Project **IEEE 802.16 Broadband Wireless Access Working Group** <<http://ieee802.org/16>>

Title **Proposed changes to clause 15.1.3**

Date **2007-09-07**
Submitted

Proposed changes to clause 15.1.3

Figure h23—Initialization brief procedures of BS initialization and operation for coexistence—BS[mg3][h4]

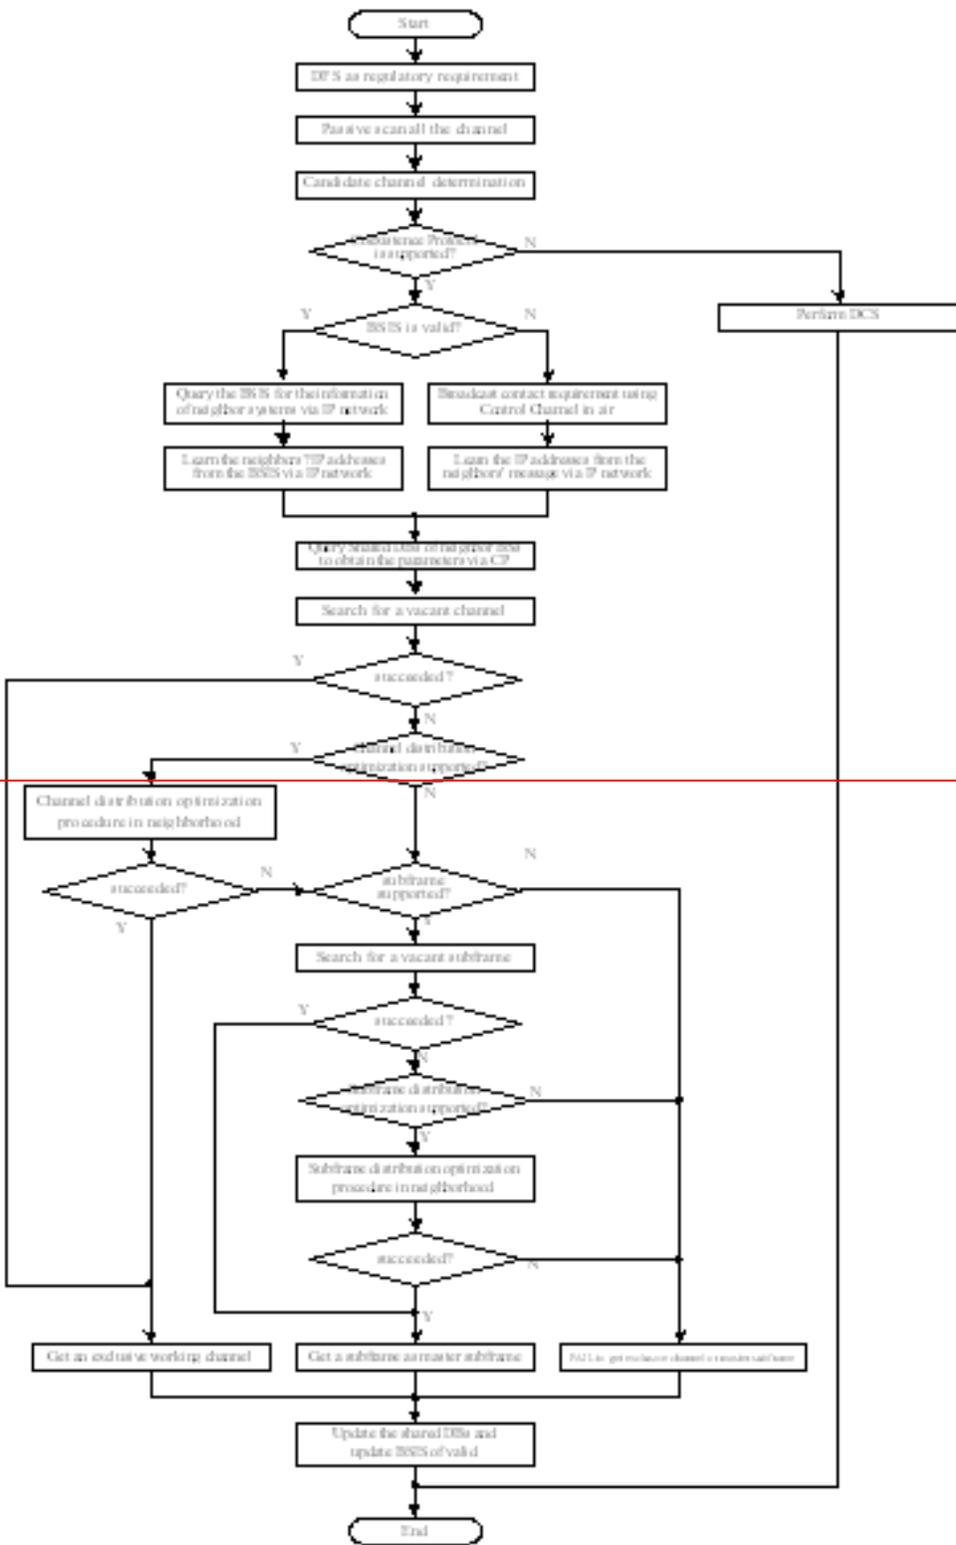
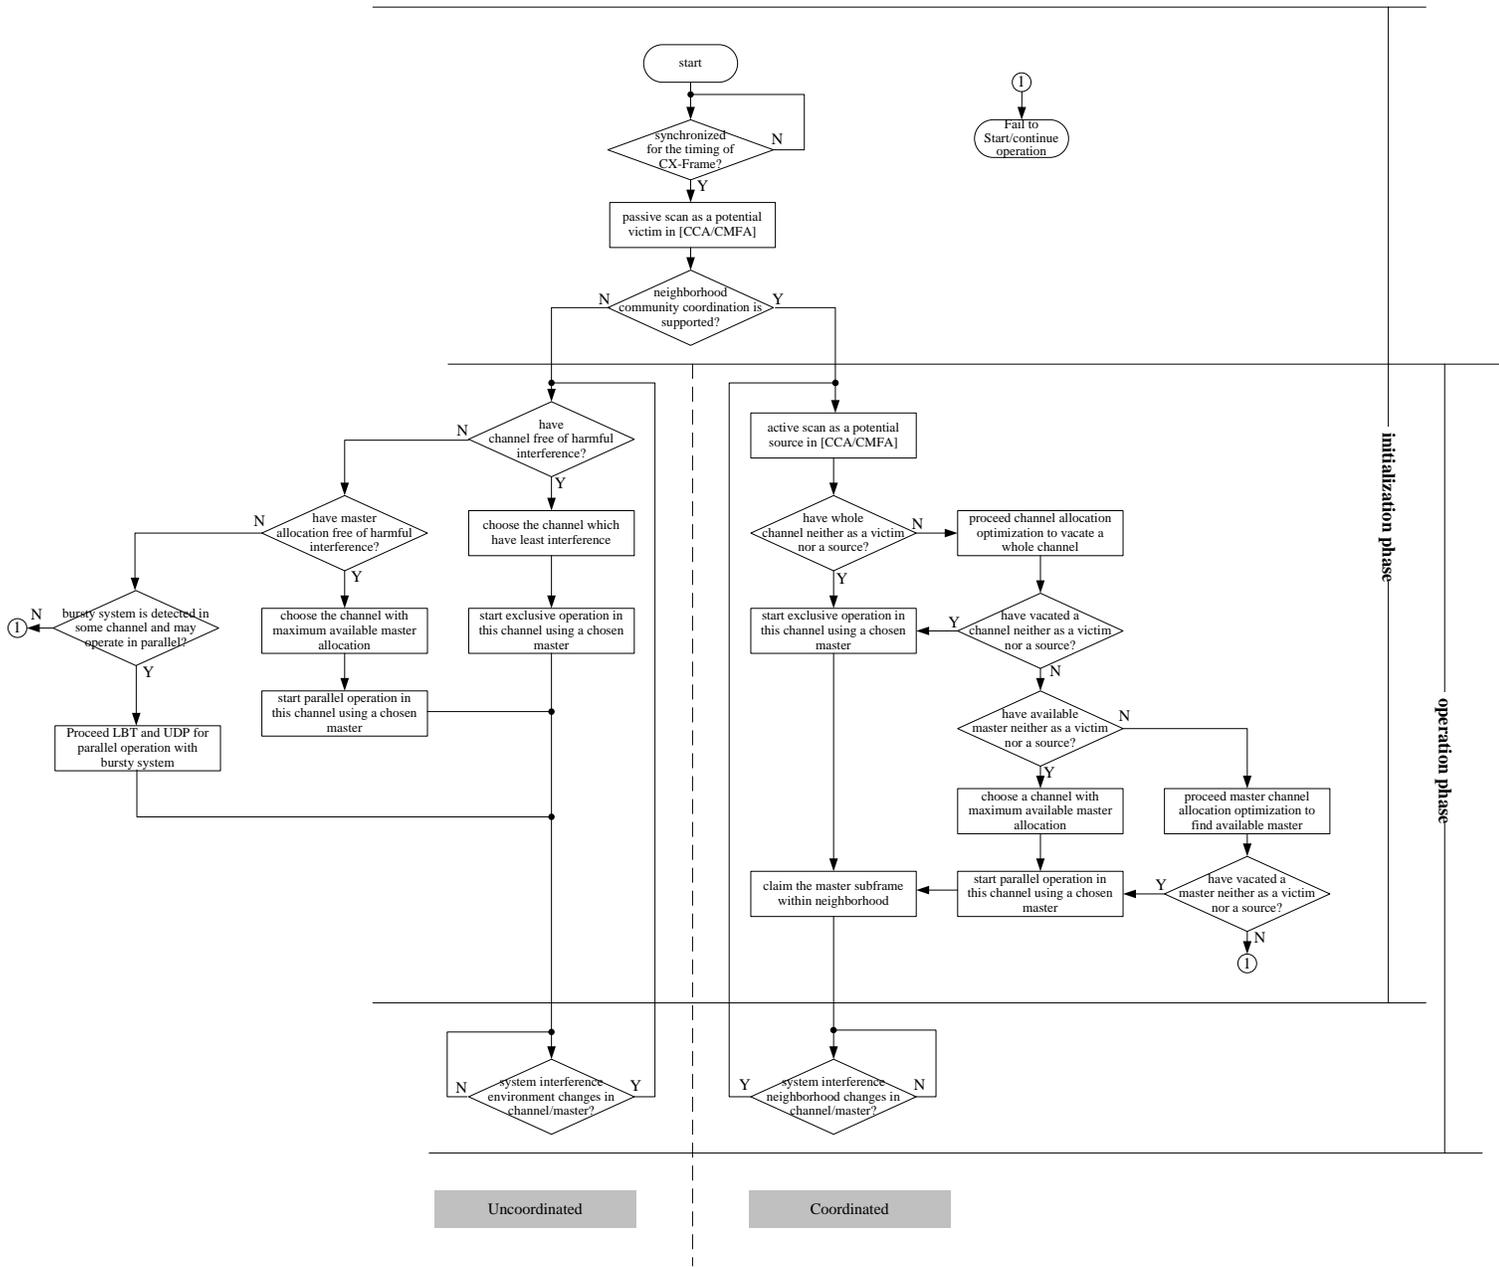
Comment 40 by David:

Creation of sub-frame is no more considered given the new CX Frame structure.

2) Update accordingly the Figure h16 (fig. h23 in D2c)

1) Remove following sentences:

- "If an exclusive existing subframe is not available, the IBS will then try to negotiate with the systems inside the community to create a new sub-frame."
- "Note, that the procedures that the BS uses to create a Master slot or channel switching are also applicable for the operating stage."

Figure h25—procedure in the operating stage(B)

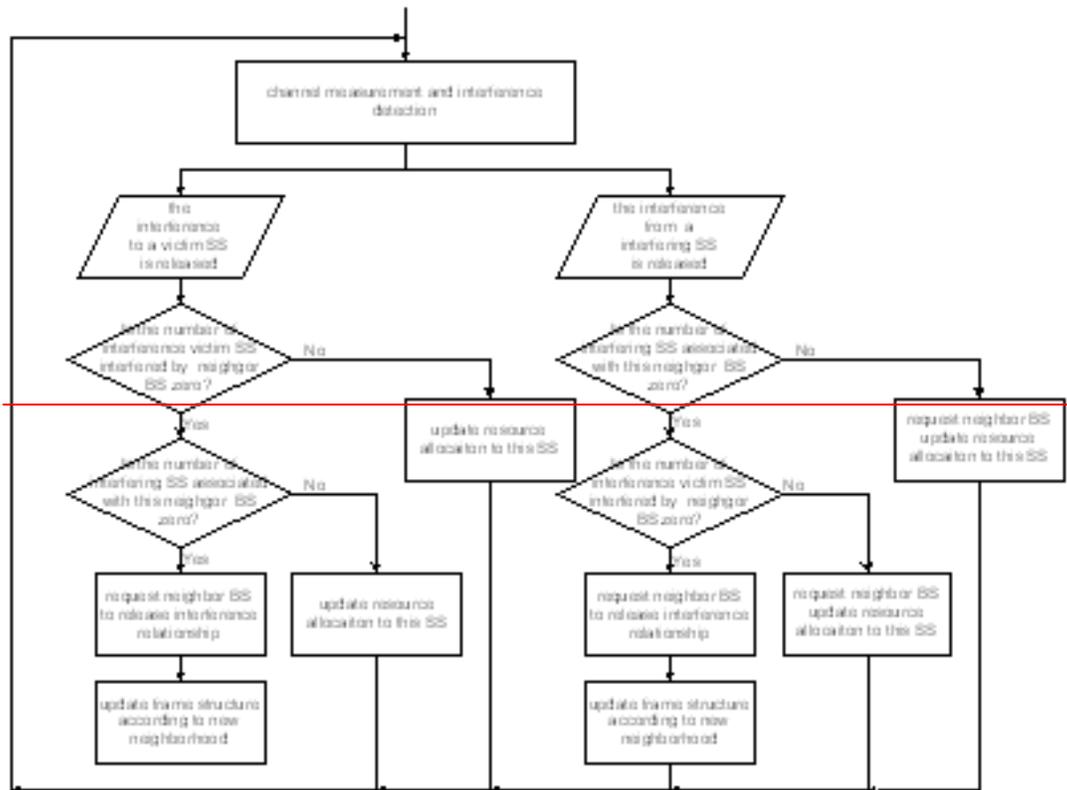
~~Figure h 24 Figure h 25 shows the procedure for the WirelessMAN-CX BS in operating stage.~~
